## SERVICE BULLETIN

### No. SB-NG-2-23

**Subject:** FWD Tail Spring Attachment Bracket

**Aircraft affected:** EXTRA NG: S/N NG001 through NG040,  
except related SL-NG-2-22 was already complied with.

*Fig.: Front attachment tail landing gear*

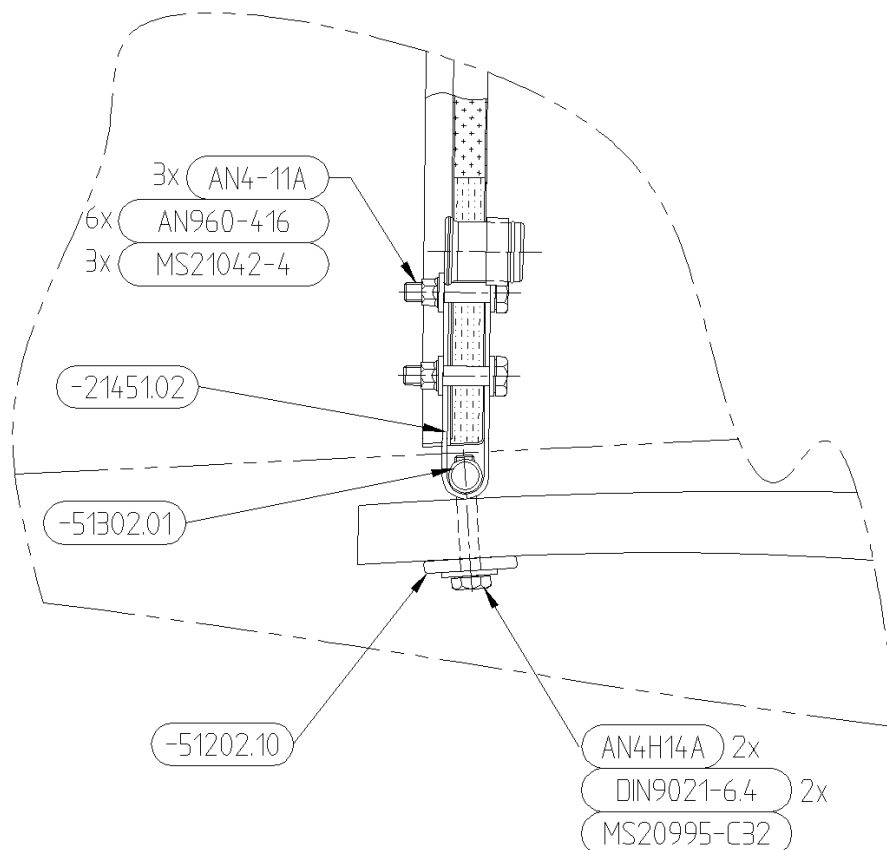
1. Remove Tail Spring as per chapter 32-10-03 of the EXTRA NG Maintenance Manual (AMM).
2. Remove 3 bolts (AN4-11A) connecting the original fwd tail spring bracket (EX-21451.02) to the fuselage, then remove bracket. Keep bearing shaft (EX-51302.01).

3. Apply grease (MIL-PRF-81322G or equivalent) to the bearing shaft (EX-51302.01) and insert into the improved bracket (EX-21451.02, Version A).

4. Reinstall the improved bracket (EX-21451.02, Version A) into fuselage. Use new locknuts (MS21042-4) and tighten bolts according to standard torque values (see chapter 20-10-03 of AMM).
5. Reinstall tail spring as per chapter 32-10-03 of the AMM. Secure the two bolts (AN4H14A) at the forward bracket with safety wire (see Figure above and Figure 3 in Chap. 32-10-04 of the AMM).
